**Request for Additional Information No. 218 (2613), Revision 0**

**U. S. EPR Standard Design Certification**

**SRP Section: 03.04.01 - Internal Flood Protection for Onsite Equipment Failures**

Figure 9.5.1-1—Fire Water Distribution System  
Sheet 4 of 13

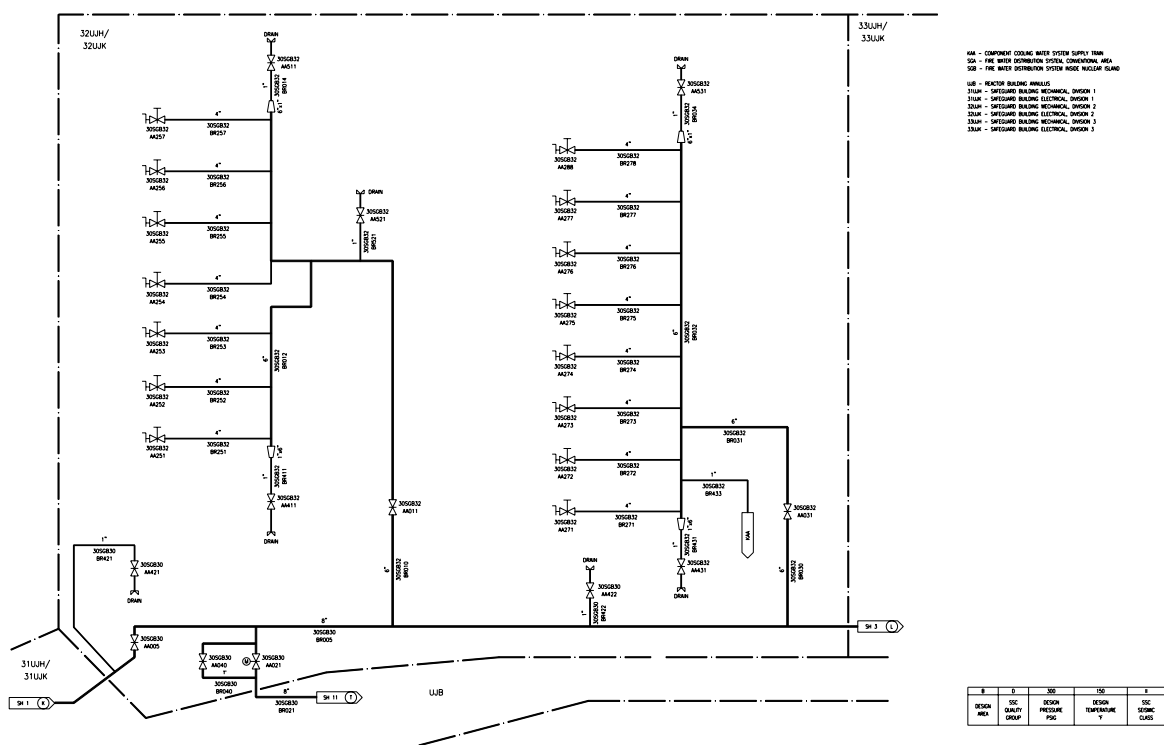
- U.S. EPR FSAR, Tier 2, Table 6.2.4-1 will be revised to show the position of the FWDS containment isolation valves as normally closed.
- U.S. EPR FSAR, Tier 2, Section 9.5.1 will be revised to change FWDS annulus isolation valves SGB30AA021 and SGB30AA022 to normally closed motor operated valves.
- U.S. EPR FSAR, Tier 2, Figure 9.5.1-1 (Sheets 4 and 7) will be revised to add a normally open bypass line around the FWDS annulus isolation valves.

U.S. EPR FSAR, Tier 2, Table 1.8-2, Table 3.2.2-1, Section 3.4.1, Table 3.4-1, Section 3.4.3.3, Table 6.2.4-1, Section 9.5.1, and Figure 9.5.1-1 will be revised as described in the response and indicated on the enclosed markup.
